SUBJECT: AMENDING ORDINANCE NO. 89-044 TO MODIFY  
A REZONE CONDITION (P88-432) REQUIRING  
A 3.5 FOOT TURFED UNDULATING BERM WITHIN  
THE 25 FOOT SETBACK AREA TO ALLOW DROUGHT  
TOLERANT LANDSCAPING WITH NO IRRIGATION  
FOR A 96 UNIT APARTMENT COMPLEX (P91-012)

**ORDINANCE NO. 91-038**

AMENDING ORDINANCE NO. 89-044 TO MODIFY A REZONE  
CONDITION (P88-432) REQUIRING A 3.5 FOOT TURFED  
UNDULATING BERM WITHIN THE 25 FOOT SETBACK AREA TO  
ALLOW DROUGHT TOLERANT LANDSCAPING

(P91-012) (APN: 029-021-20, 21, 34; 029-010-02, 06)

PLANTING PLAN  
3RD & RIVERSIDE  
APARTMENTS

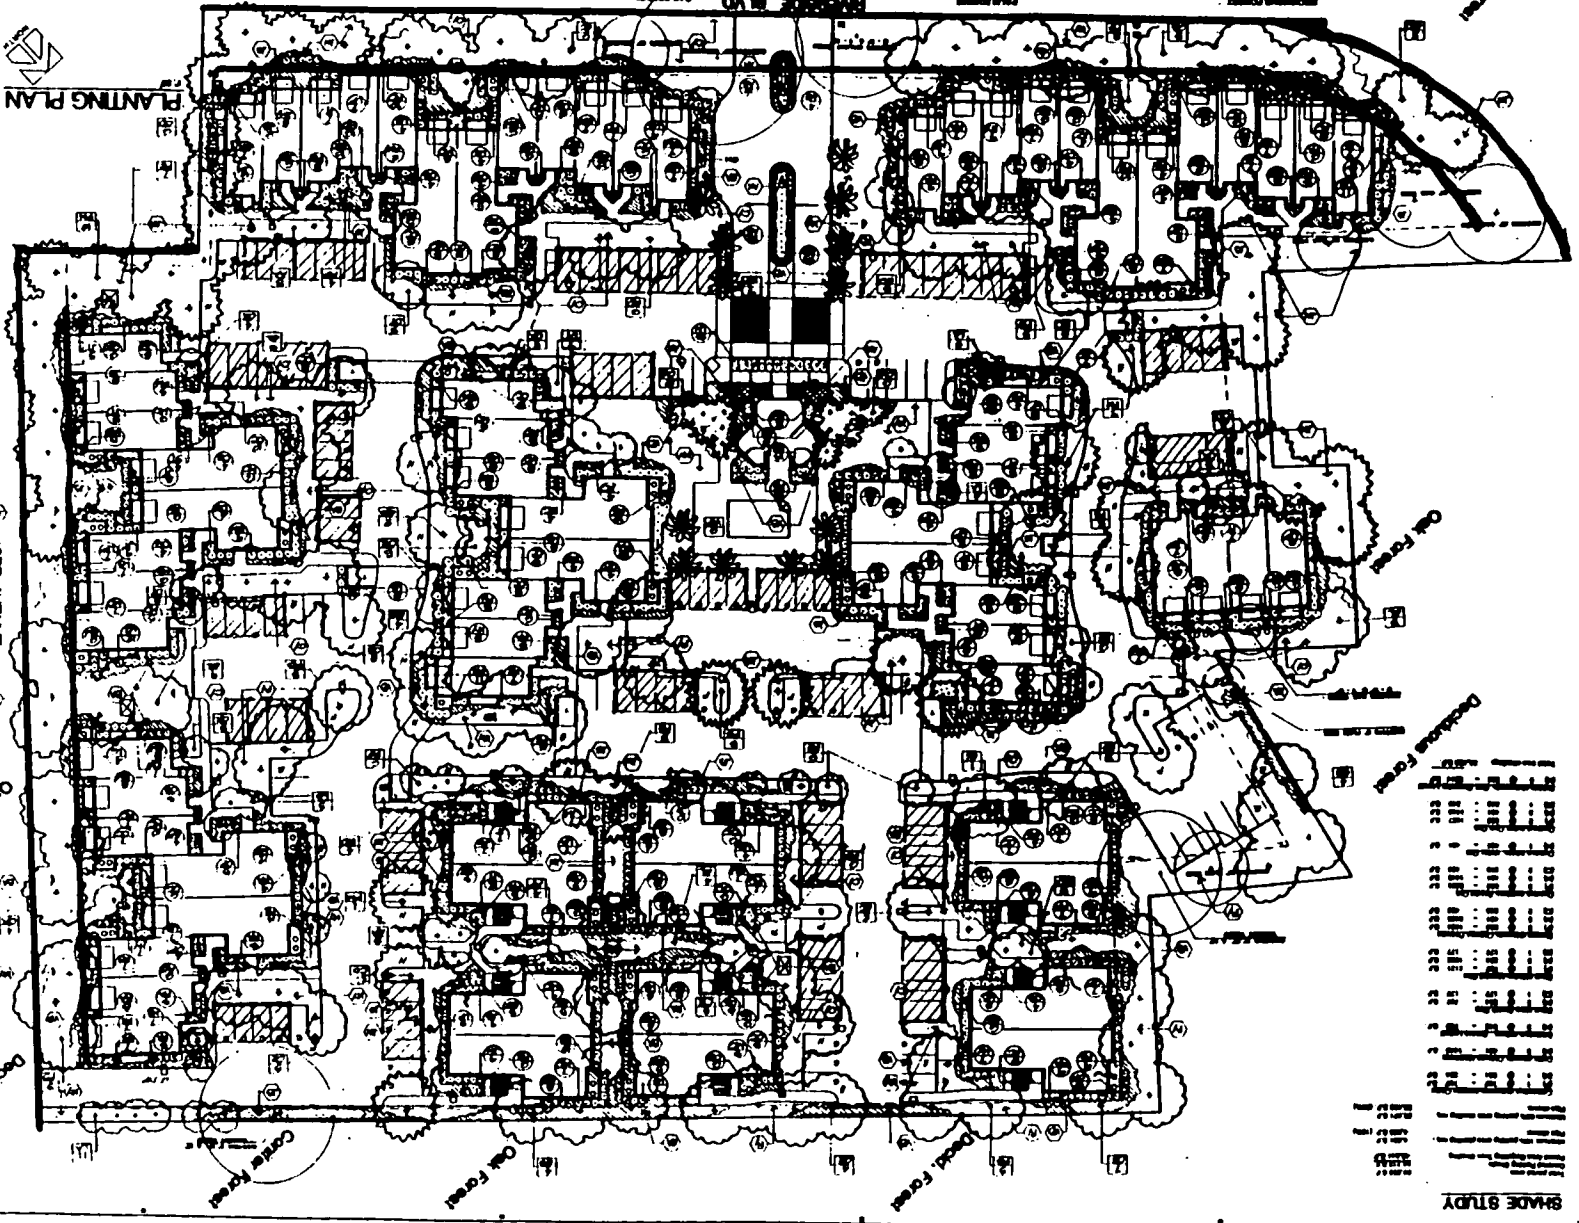
1. The applicant shall landscape the setback areas along 43rd Avenue and Riverside Boulevard with drought resistant landscaping, as submitted, to include sloping as necessary for proper drainage. The applicant shall use a drought resistant tall fescue or rye sod as ground cover in the setback areas. No bark, masonry rock, or other non-living cover will be the primary ground cover in the setback areas. The applicant shall submit revised landscaping plans for review and approval by the City's Landscape Architect and Planning Director prior to the issuance of building permits.

2. Any area within the apartment complex that uses bark or masonry rock as the primary ground cover shall have weed cloth installed beneath it. This shall be indicated on the landscape plan.

- \* c. The City Council, on May 28, 1991, amended the rezone condition and required the following:
  1. Drought resistant tall fescue or rye sod shall be used as ground cover in the 25 foot front setbacks on Riverside Boulevard and 43rd Avenue.
  2. A standard irrigation system shall be used in the front 25 foot setback areas along the street frontages.
  3. A 3.5' undulating berm shall be included in the front 25 foot setback areas.
  4. Drought resistant plants, shrubs and trees with a drip system may be used in the remaining portion of the apartment complex.
  5. A landscape-irrigation plan indicating the above items must be submitted to the Planning Director and City Landscape Architect for review and approval prior to issuance of building permits.
